## Arlington Conservation Commission

#### **DEP #091-0375: Notice of Intent: 26 Dudley Street.**

**From:** Geilen, Alicia (DEP) <Alicia.Geilen@mass.gov>  
**Sent:** Tuesday, November 25, 2025 4:27 PM  
**To:** Richard Kirby  
**Cc:** Nicole Ferrara; David Morgan; Jackie Anderson  
**Subject:** RE: MassDEP NOI File Number 26 Dudley St., Arlington

*Site Plan*

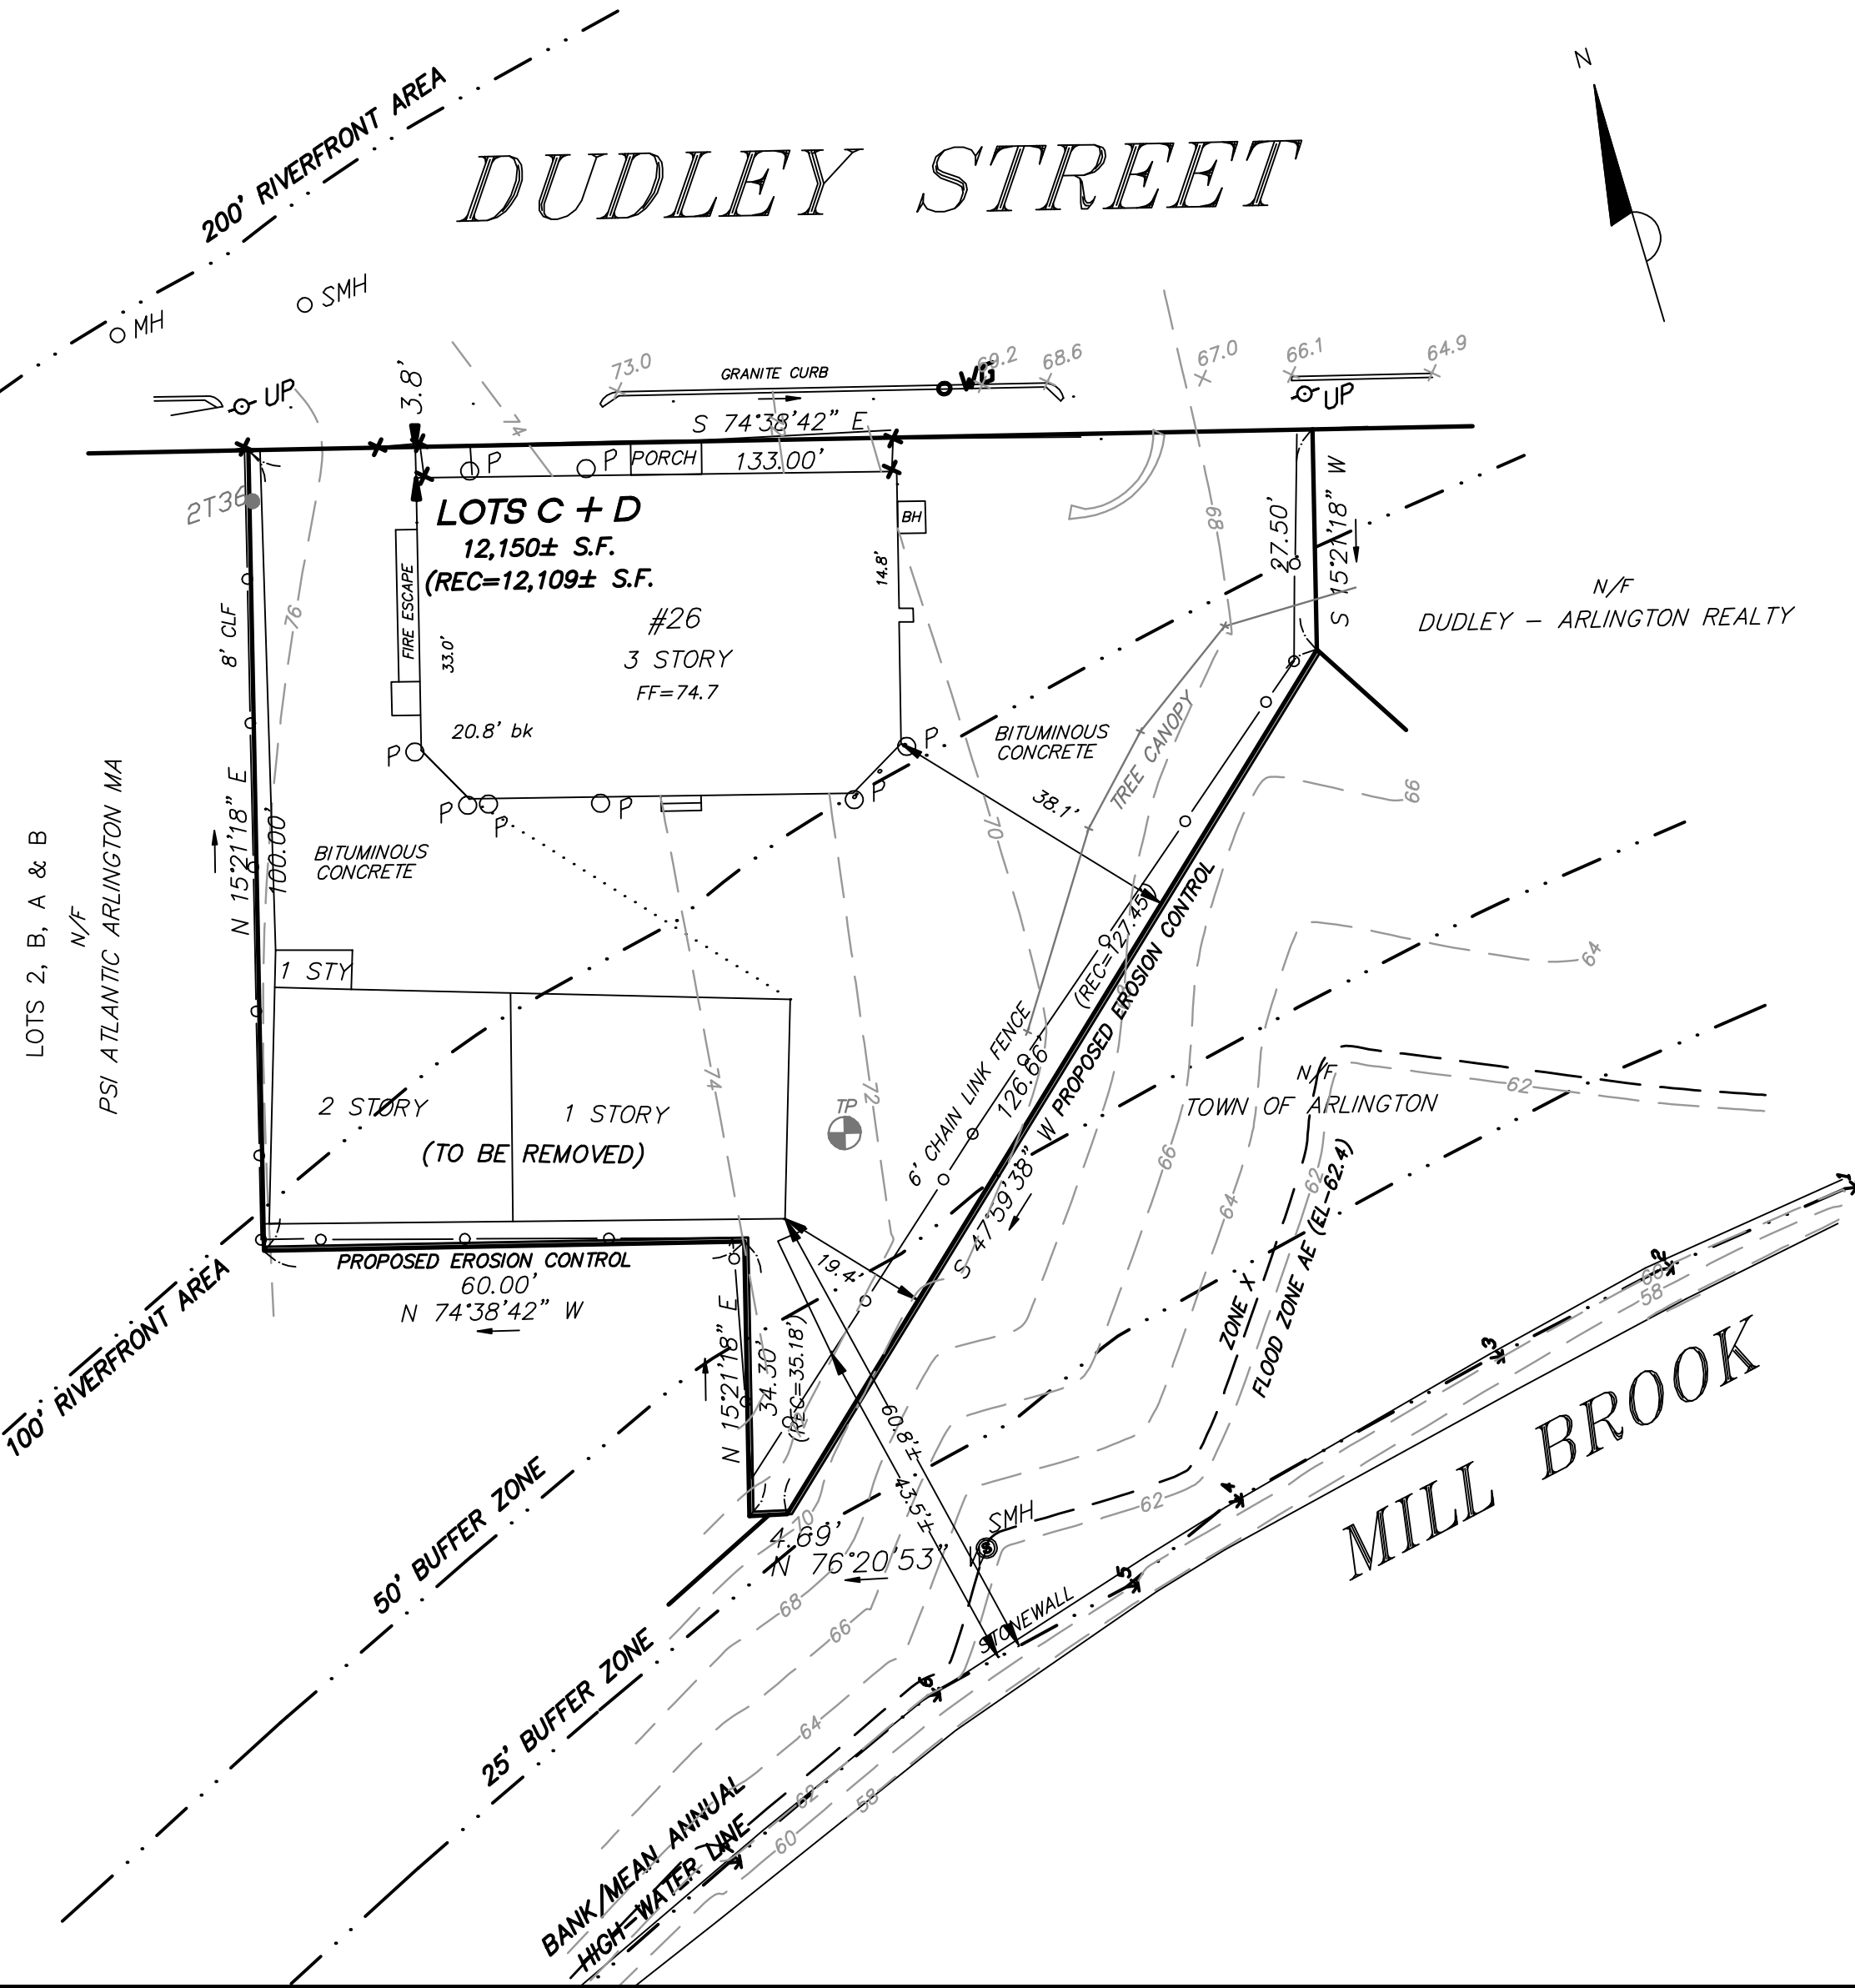
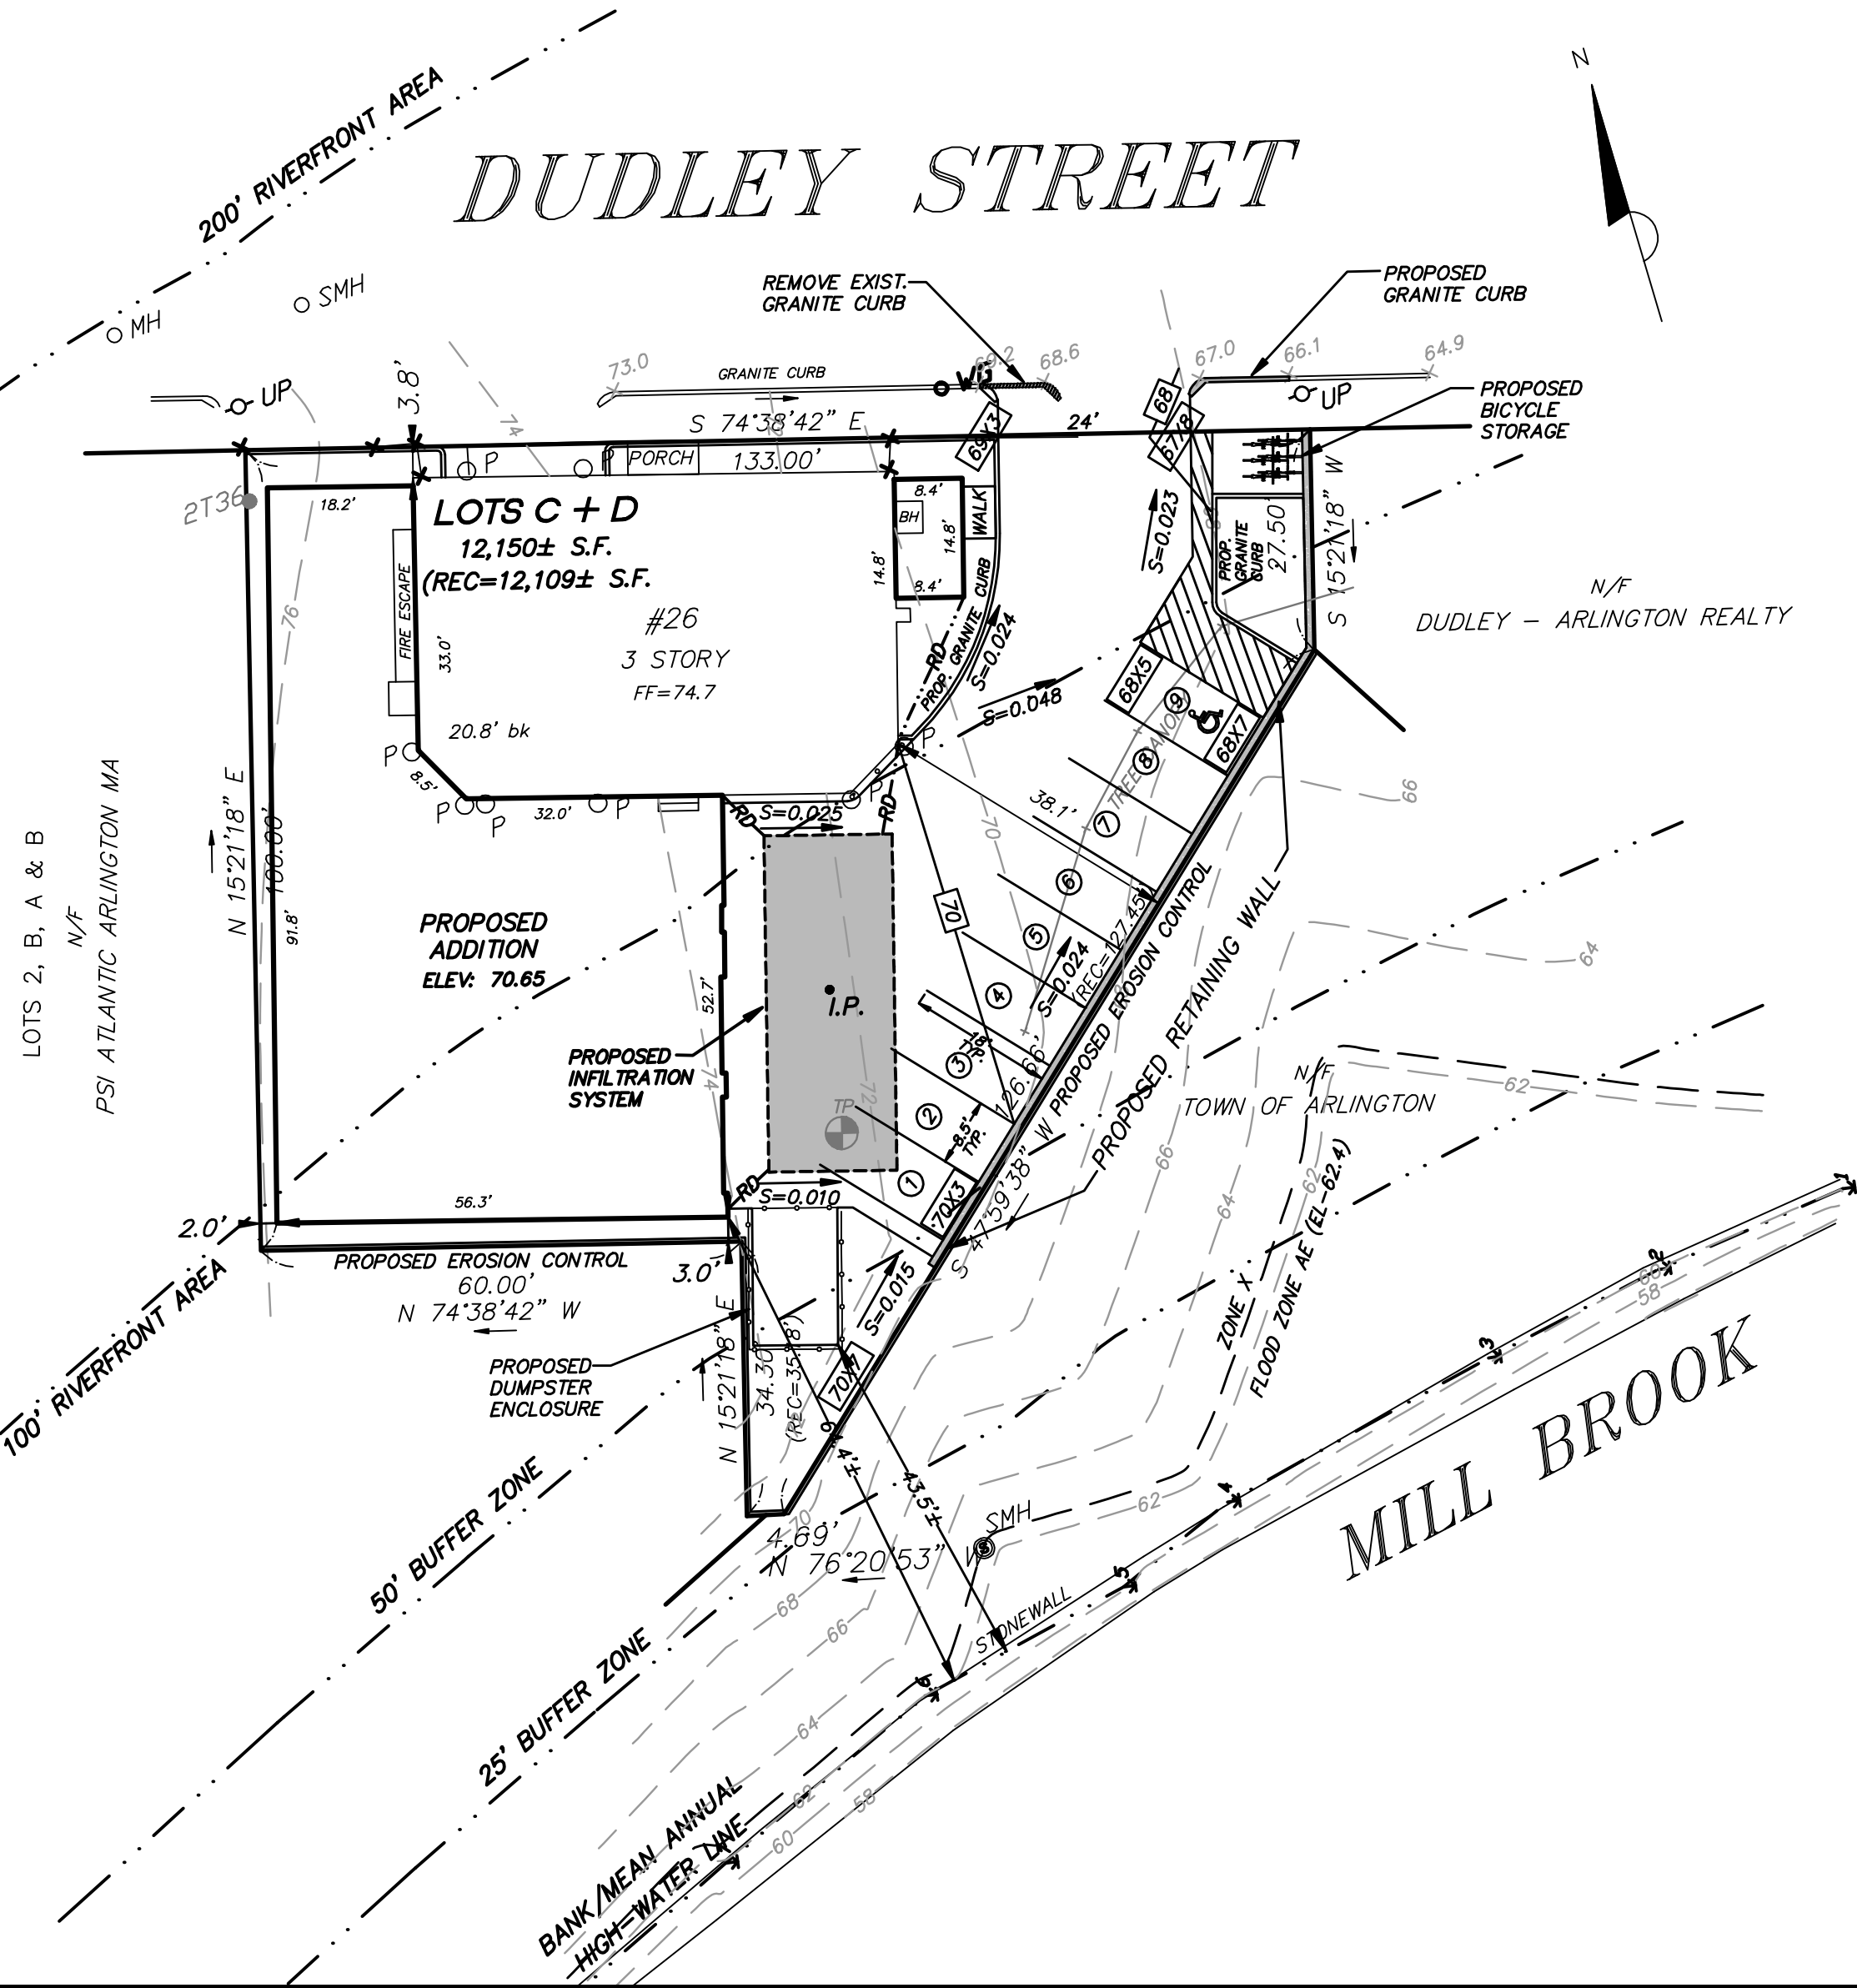
Project does not appear to meet 10.58(5) as proposed. A plan that more clearly indicator exisiting degraded and existing non-degraded areas is needed.

10.58(5)(a) - Project must include an improvement over existing conditions of the capacity of the riverfront area to protect the interests of the WPA. A reduction of 35 sf of impervious surface spread across the site does not provide a meaningful improvement. Mandatory stormwater management does not count as an improvement, because 10.58(a) is a stand-alone requirement, also discussed in 10.58(5).

INFILTRATION SYSTEM DETAIL

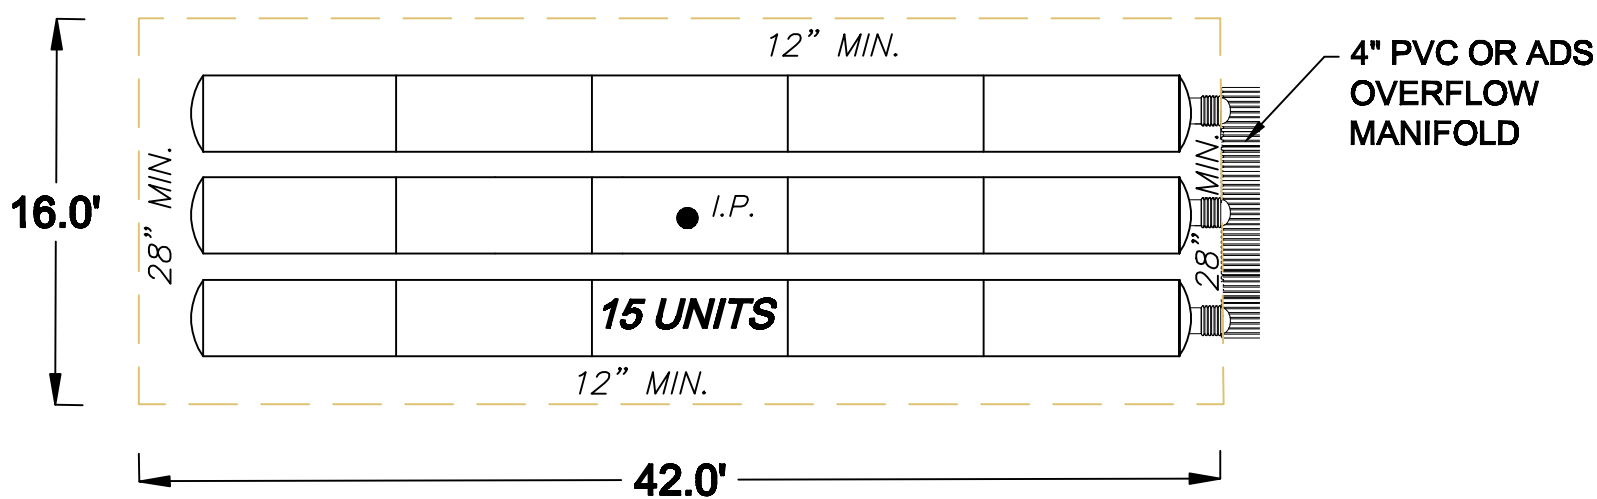
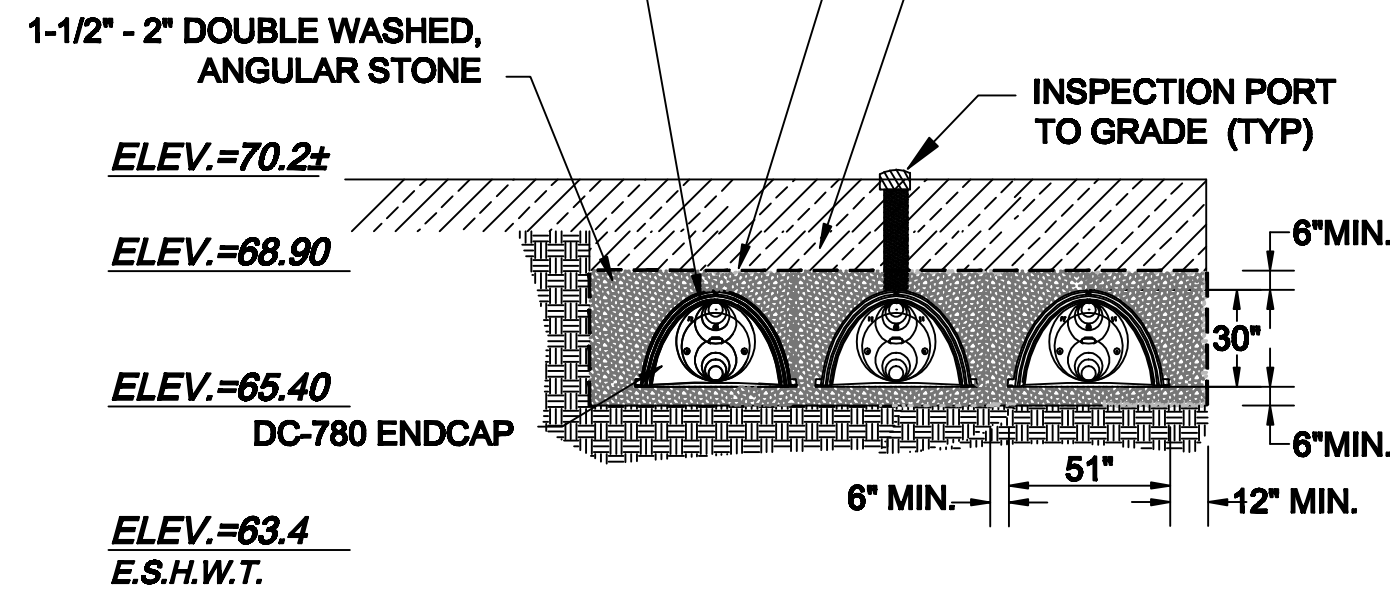
The infiltration unit appears to only remove 25% TSS not 80%, and requires pretreatment. The Commission should request additional information on how 80% TSS removal will be achived.
